WOLF CREEK UNIT 1

WOLF CREEK - UNIT 1

ATTACHMENT IV

Figure 6.2-1 Operating Corporation Organization

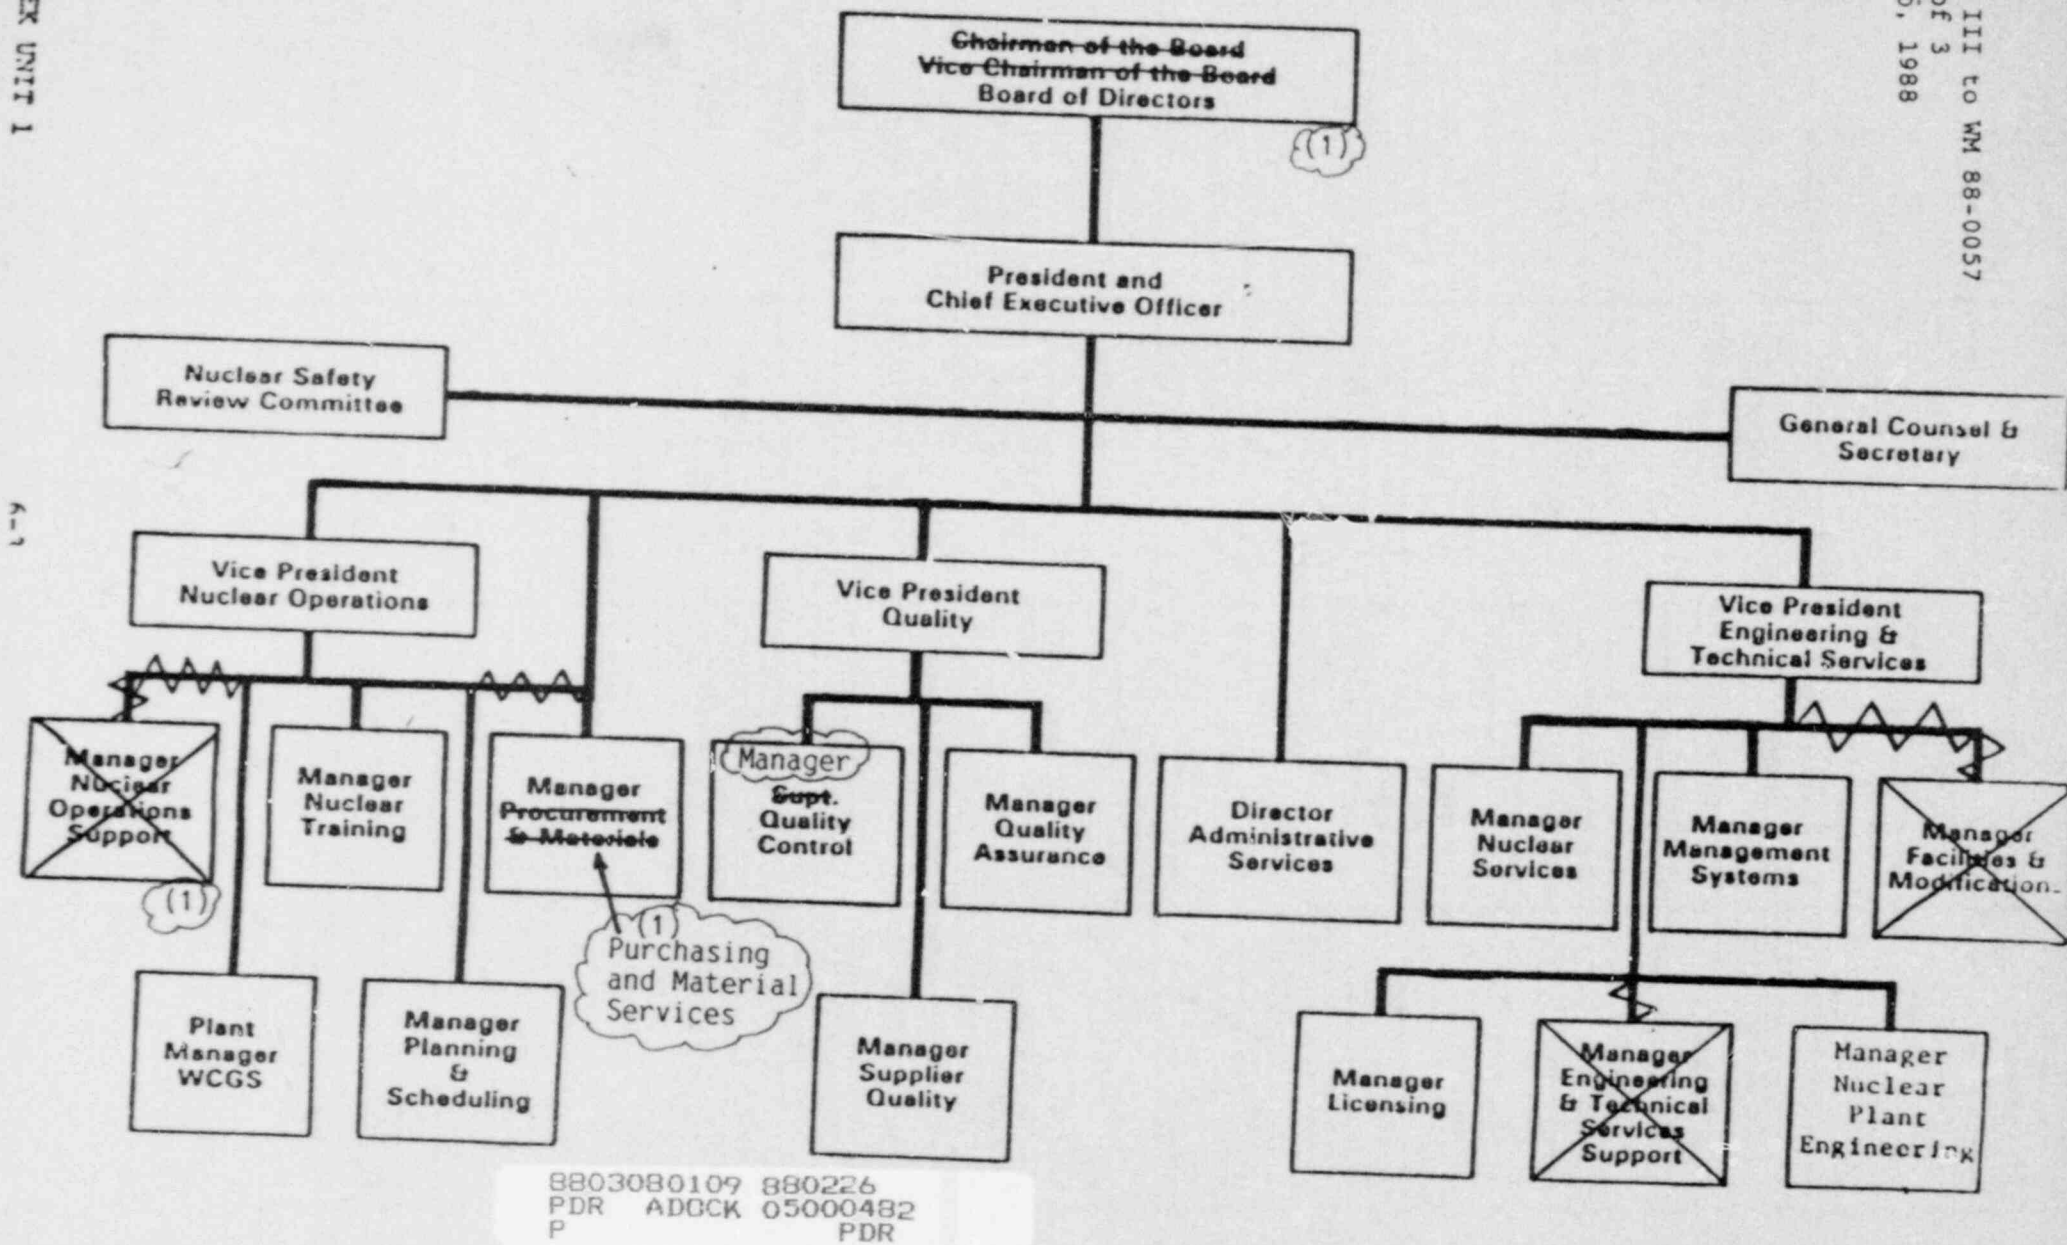
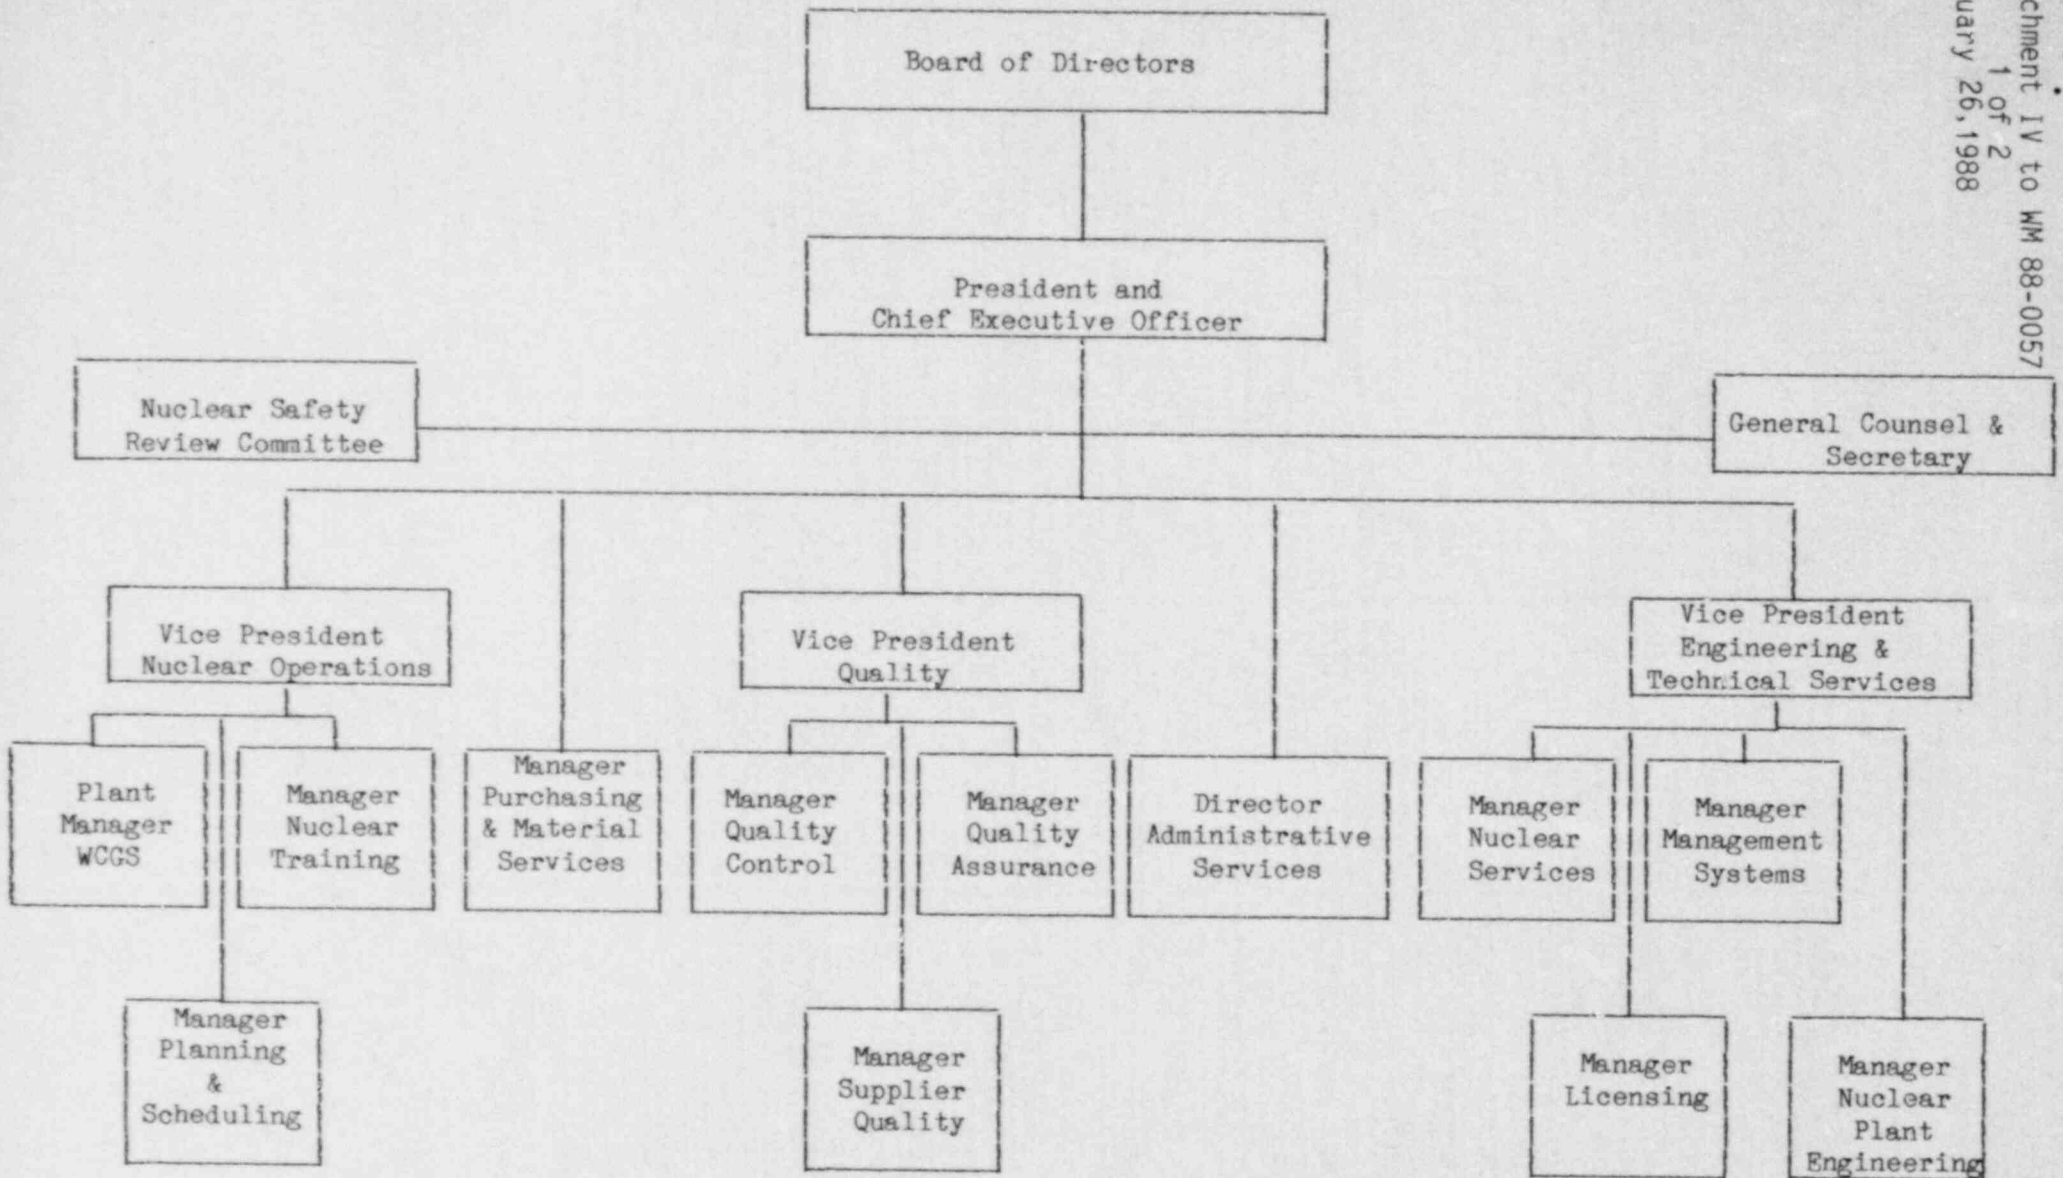
(1) These changes previously submitted per ET 87-0292
